MILITARY SPECIFICATION SHEET

RELAYS, ELECTROMAGNETIC, ESTABLISHED RELIABILITY, 3PDT,
LOW LEVEL TO 10 AMPERES, PERMANENT MAGNET DRIVE, MAGNETIC LATCH
HERMETICALLY SEALED, ALL WELDED, TRANSIENT SUPPRESSED DC COIL

This amendment forms a part of MIL-R-83536/24, dated 27 March 1992, and is approved for use by all Departments and Agencies of the Department of Defense

CIRCUIT DIAGRAM
(ALTERNATE INTERNAL
DIODE CONFIGURATION)

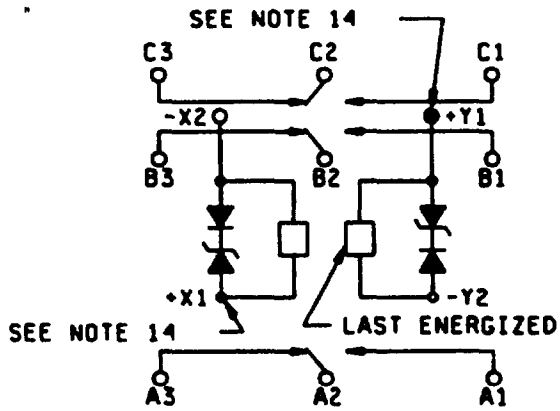
FIGURE 1, add the following circuit diagram
